AMENDMENTS TO THE DRAWINGS

5 The attached sheets of drawings include two “Replacement Sheets” and two
“Annotated Sheets Showing Changes”. There is one of each for both Fig. 1 and Fig.
12. The “Annotated Sheets Showing Changes” illustrate what was eliminated and
what was added in red ink, while the “Replacement Sheets” represent the new
diagrams in clean form.

Fig. 1 Prior art

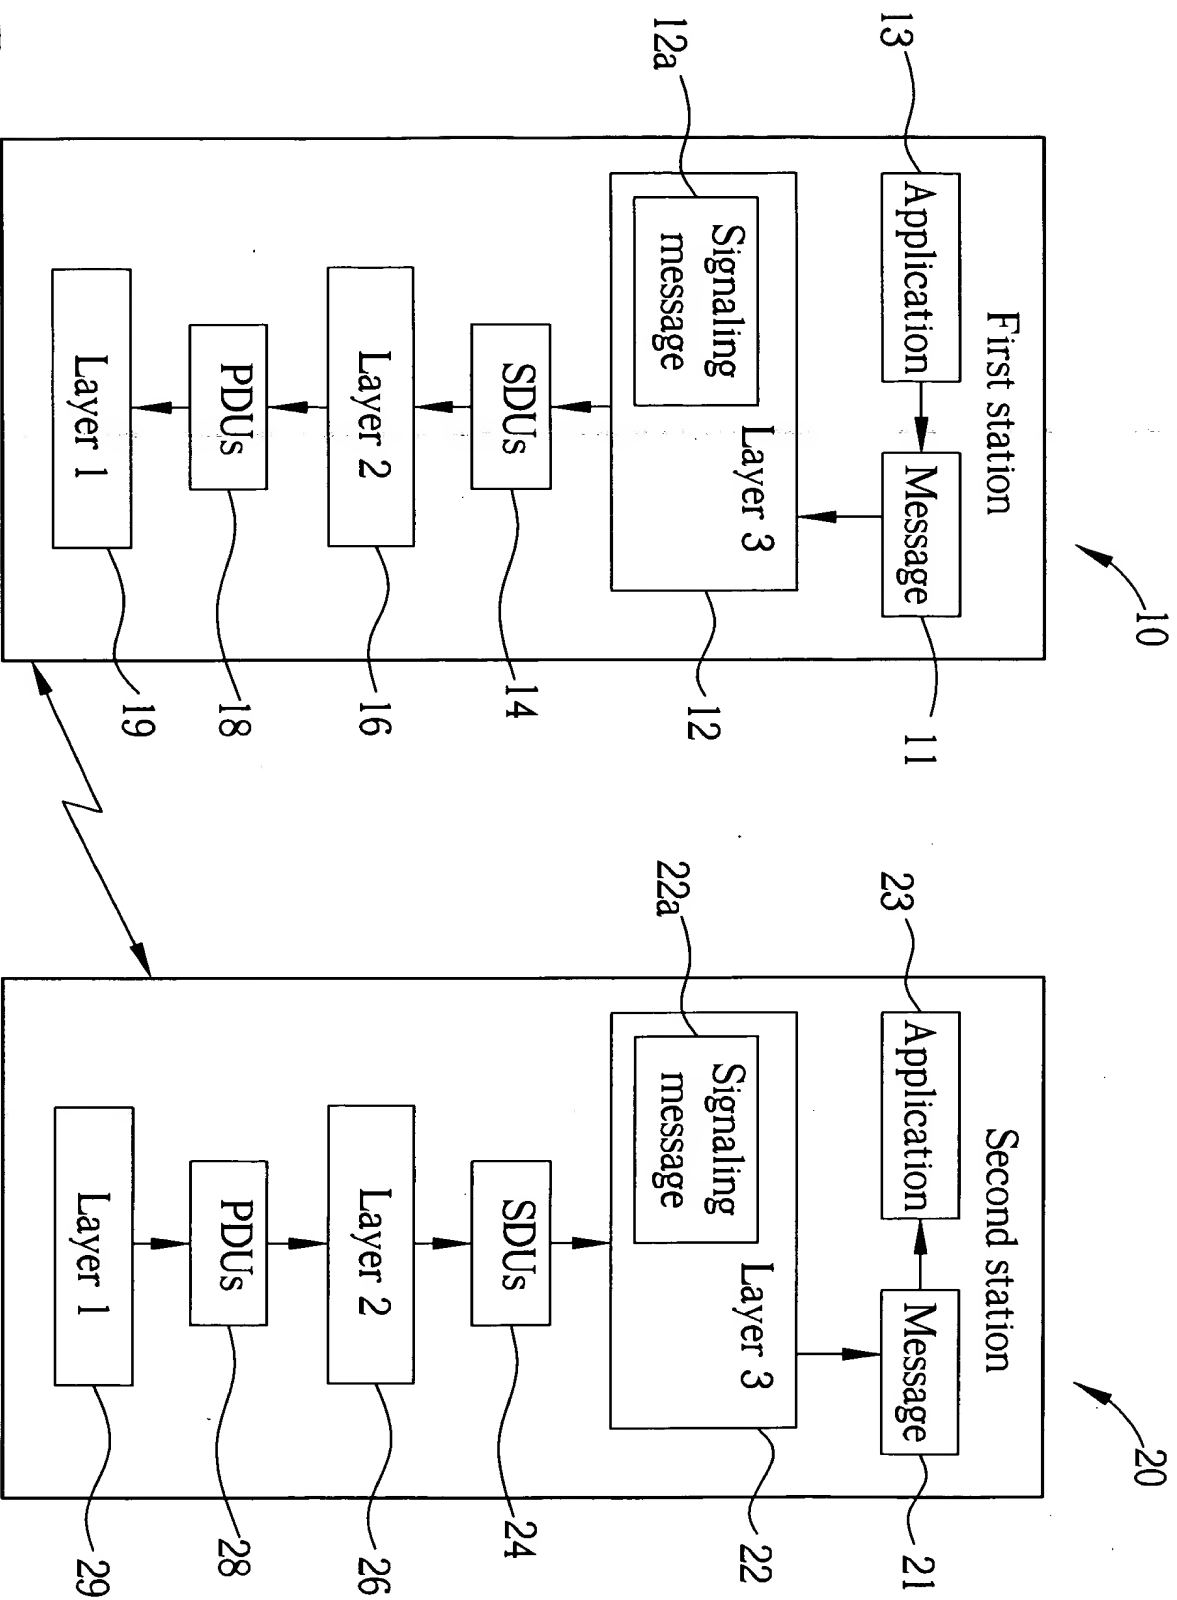
The double-arrowed line 14, intended to represent SDUs, has been replaced with
the block 14 containing the word SDUs inside, and 2 downward arrows between
blocks 14 and 12, and between blocks 14 and 16, respectively.

15 The double-arrowed line 18, intended to represent PDUs, has been replaced with
the block 18 containing the word PDUs inside, and 2 downward arrows between
blocks 18 and 16, and between blocks 18 and 19, respectively.

The double-arrowed line 24, intended to represent SDUs, has been replaced with
the block 24 containing the word SDUs inside, and 2 upward arrows between blocks
24 and 22, and between blocks 24 and 26, respectively.

20 The double-arrowed line 28, intended to represent PDUs, has been replaced with
the block 28 containing the word PDUs inside, and 2 upward arrows between blocks
28 and 26, and between blocks 28 and 29, respectively.

Fig. 12

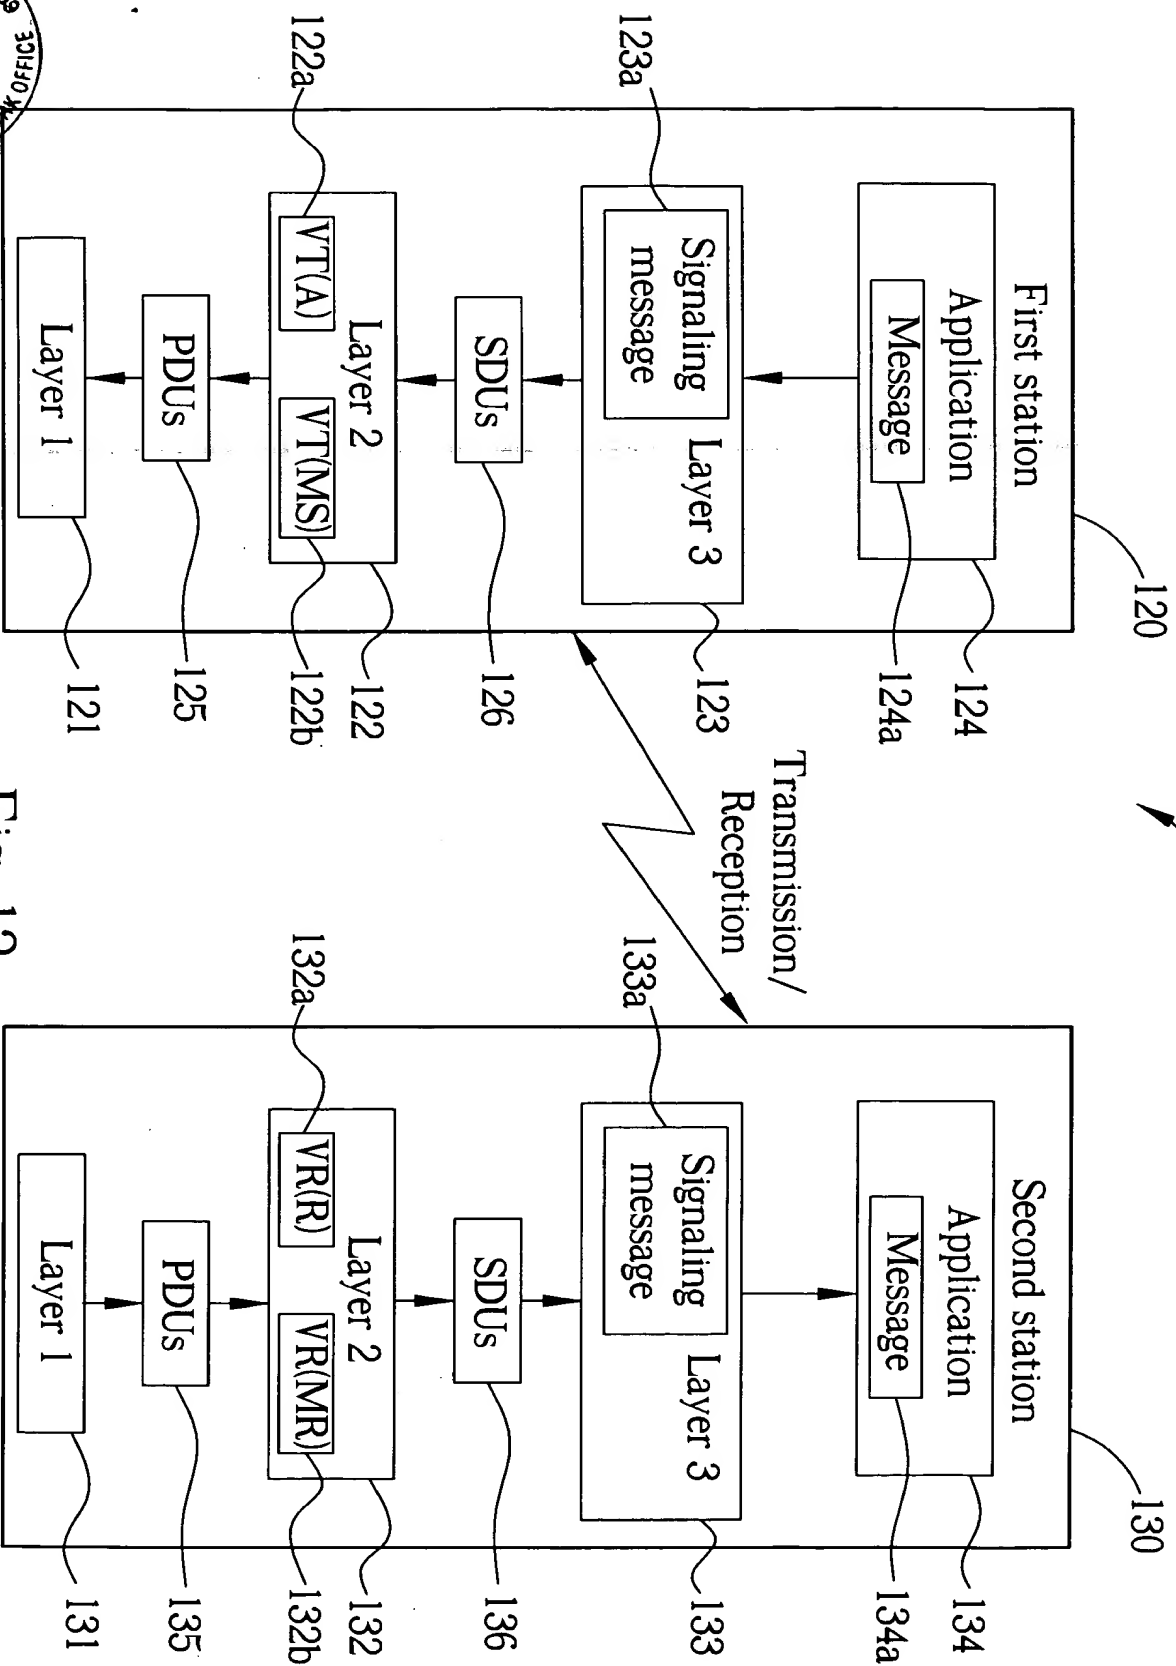
25 The double-arrowed line 126, intended to represent SDUs, has been replaced
with the block 126 containing the word SDUs inside, and 2 downward arrows between
blocks 126 and 123, and between blocks 126 and 122, respectively.

The double-arrowed line 125, intended to represent PDUs, has been replaced
with the block 125 containing the word PDUs inside, and 2 downward arrows between
30 blocks 125 and 122, and between blocks 125 and 121, respectively.

The double-arrowed line 136, intended to represent SDUs, has been replaced
with the block 136 containing the word SDUs inside, and 2 upward arrows between

blocks 136 and 133, and between blocks 136 and 132, respectively .

The double-arrowed line 135, intended to represent PDUs, has been replaced with the block 135 containing the word PDUs inside, and 2 upward arrows between blocks 135 and 132, and between blocks 135 and 131, respectively .

- 5 The double-arrow between blocks 124 and 123 has been replaced with a downward arrow between blocks 124 and 123.

The double-arrow between blocks 134 and 133 has been replaced with an upward arrow between blocks 134 and 133.
